SERVICE BULLETIN

94-1

SUBJECT: NEW STYLE CRANKCASE HEATER FOR
RECIP "J" COMPRESSORS, STYLE E & F

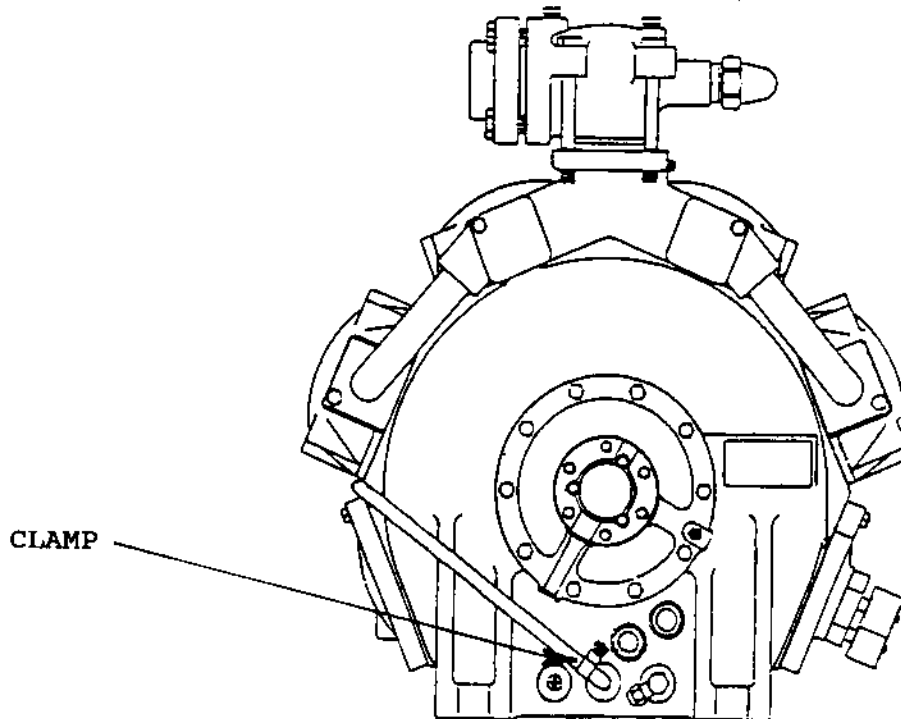
A change has been made to a new style crankcase heater on current production "J" compressors. The new heater is the result of a vendor change. With the change in oil heater comes a part number change. This is necessary because the new heater requires a clamp to hold it in place. See the drawing below:

The new style heater should not be used to replace the old style because it will not stay in the compressor block without the clamp. If the heater backs out of the compressor block, it will burn up. To use the new heater and clamp to replace an old style heater, the compressor block requires drilling and tapping. If done incorrectly, permanent damage to the block may result. As a result of this, when a heater fails, the style should be verified and an exact replacement ordered. The following part numbers should be used to assure the heater is replaced with an identical replacement.

OLD STYLE HEATER (No clamp)

120 VOLT: 025-10462-000
230 VOLT: 025-13553-000

NEW STYLE HEATER (WITH CLAMP)

120 VOLT: 025-29650-000
230 VOLT: 025-29651-000

CLAMP: 023-09249-000
SCREW: 021-16174-000
